ADDENDUM NO. 1

IRONDALE FIRE STATION No. 3

THIS ADDENDUM FORMS A PART OF THE CONTRACT DOCUMENTS. THE FOLLOWING CONDITIONS TAKE PRECEDENCE OVER ANY CONFLICTING CONDITIONS IN THE DRAWINGS AND SPECIFICATIONS. THE DRAWINGS AND SPECIFICATIONS ARE HEREBY AMENDED IN THE FOLLOWING PARTICULARS.

SHEET TITLE	:
PLUMBING	SCHEDULES AND
NOTES	
PROJECT NU	JMBER:
CWA No. 2	023-01

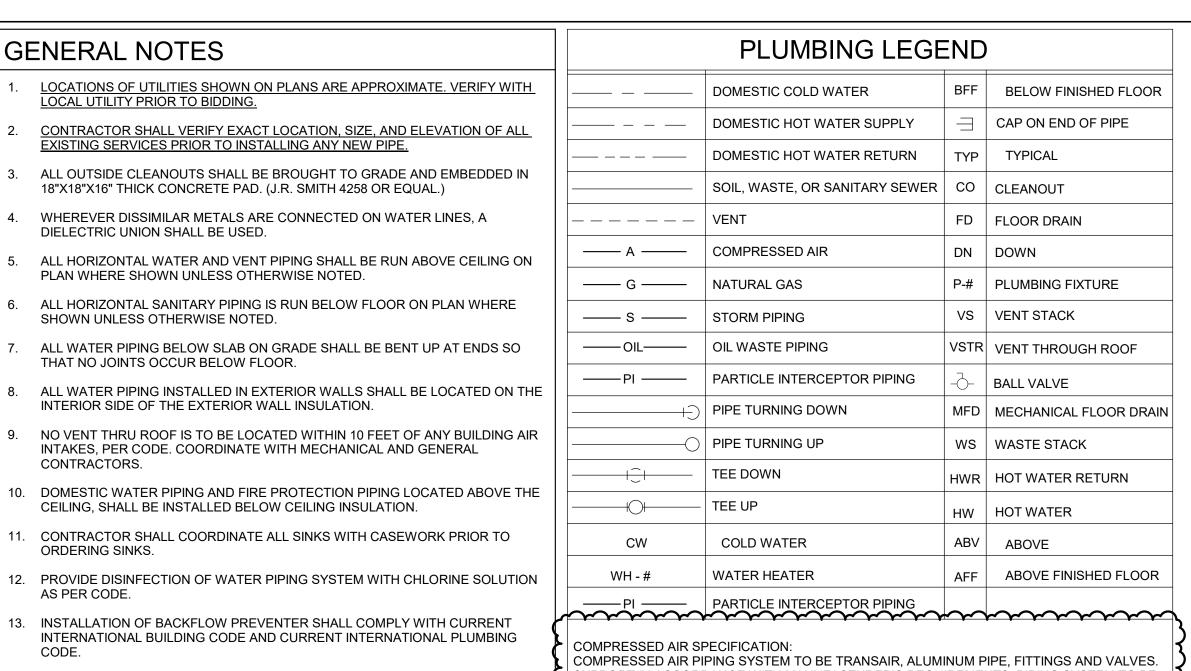
- 1. P0.1 Plumbing Schedules and Notes:
 - a. Clarified electrical information for water heaters WH-1, WH-2 and WH-3.
 - b. Addition of compressed air specification.
 - c. Clarified power requirements for AC-1 of Plumbing Fixture Schedule
- 2. P0.2 Plumbing Details: updated water heater detail
- 3. <u>P1.1 Non-pressure Piping Floor Plan</u>: Adjustment of mechanical floor drain and water heaters location in Mech/ Elec 139.
- 4. <u>P2.1 Pressure Piping Floor Plan</u>: Adjustment of mechanical floor drain, water heaters, and air compressor location in Mech/ Elec 139
- 5. <u>P3.1 Plumbing Enlarged Plans</u>: Adjustment of mechanical floor drain, water heaters, and air compressor location in Mech/ Elec 139
- 6. M1.1 Mechanical Floor Plan: Added label for IHP-2-1

WATER HEATER SCHEDULE
MARK	FIXTURE	ELEC INFO.	MODEL	REMARKS
TWH-1	TANKLESS	208V; 1 PHASE;	EEMAX MODEL AM007240T	PROVIDE WITH INTEGRAL ASSE 1070 MIXING VALVE. PROVIDES 68°F TEMP. RISE AT 0.5 GPM. MOUNT BELOW LAVATORY WHERE SHOWN ON DRAWINGS. PIPE TO HW INLET OF FAUCET
	WATER HEATER	~5KW~~		
WH-1	WATER HEATER	208V, 3 PHASE,	HS15-050	LOCHINVARIMS 15-058, 16-04 DETAILED AT 140°F. INSTALL AS DETAILED ON
	}	15 KW		DRAWINGS. 208V, 3 PHASE, 15 KW VERIFY VOLTAGE WITH ELECTRICAL SECTION.
WH-2	WATER HEATER	208V, 3 PHASE,	HS15-050	DRAWINGS. 208V, 3 PHASE, 15 KW VERIFY VOLTAGE WITH ELECTRICAL SECTION. LOCHINVAR HIS 15 059, 40 CALLON SARRAGE, 41 GALLON RECOVERY AT 100°F RISE. NEW P&T RELIEF VALVE. SET OUTLET TEMPERATURE AT 140°F. INSTALL AS DETAILED ON
		15 KW	•	DRAWINGS. 208V, 3 PHASE, 15 KW VERIFY VOLTAGE WITH ELECTRICAL SECTION.
WH-3	WATER HEATER	208V, 3 PHASE, ⊀	HS15-050	LOCHINVAR HS 15-060, 49 GALLON STORAGE, 41 GALLON RECOVERY AT 100°F RISE. NEW P&T RELIEF VALVE. SET OUTLET TEMPERATURE AT 140°F. INSTALL AS DETAILED ON

\ \ \\\\\\\\\\\\\\\\\\\\\\\\\\\\\\\\\\	15 KW		DRAWINGS (208V, 3 PHASE, 15 KW) VERIFY VOLTAGE WITH ELECTRICAL SECTION.
		mund.
